# BUILDING CODE OF AUSTRALIA COMPLIANCE ASSESSMENT REPORT

A PROPOSED OFFICE FIT OUT IN AN EXISTING BUILDING

1 KALINYA STREET, NEWPORT

REPORT NO. ► 12197 – Rev 1

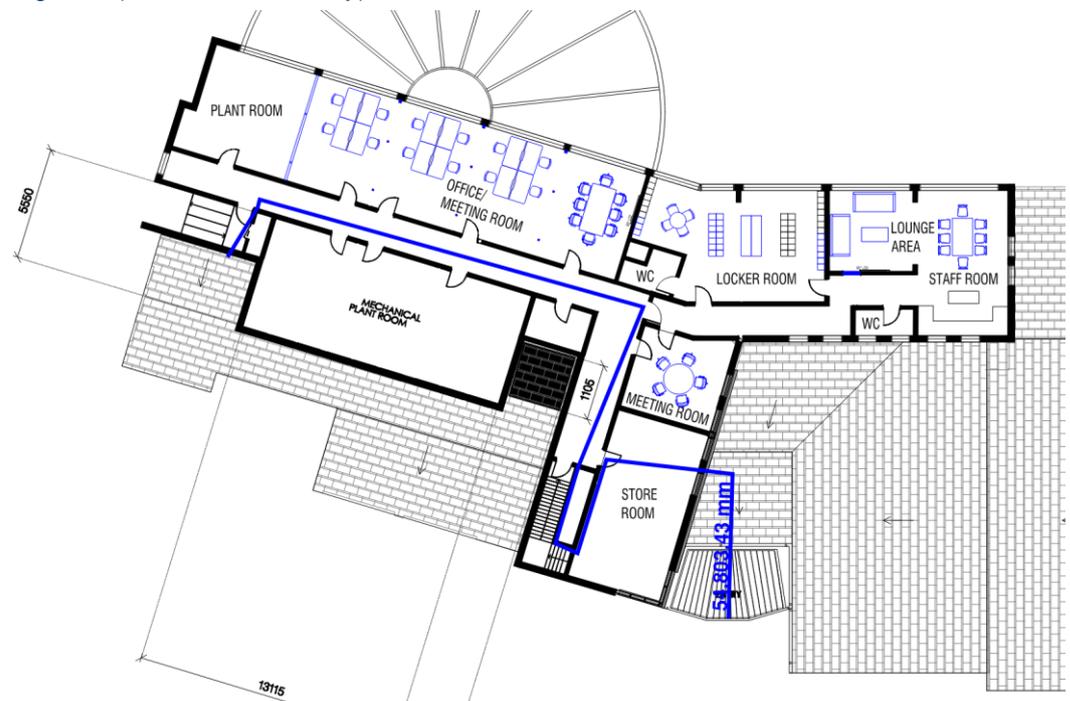
<p><b>D1.4</b> <b>Exit Distances</b></p> <p style="text-align: right;"><b>Travel</b></p>	<p>(c) <b>Class 5 buildings</b> — Subject to (d), (e) and (f)—</p> <p>(i) no point on a floor must be more than 20 m from an exit, or a point from which travel in different directions to 2 exits is available, in which case the maximum distance to one of those exits must not exceed 40 m</p> <p>At no point on the proposed tenancy must be more than 20m from an exit or a point from which travel in different directions to 2 exits is available in which case the maximum distance to one of those exits must not exceed 40m. The maximum distance to the closest exit from the furthest point of the floor is approximately 50m in lieu of 40m permitted by</p>

Clause D1.4. A Performance Solution is to be sought for this non-compliance from an accredited fire engineer (certifier – fire safety).

**D1.5**  
**Distance Between Alternative Exits**

The alternative exits serving the proposed office area subject of this report appear to be located over 60m apart.

Detailed assessment of this Clause cannot be undertaken, as base building drawings have not been provided. A measurement of the distance between the alternative exits is to be provided by other consultants.

A Performance Solution is to be sought for this non-compliance from an accredited fire engineer (certifier – fire safety).
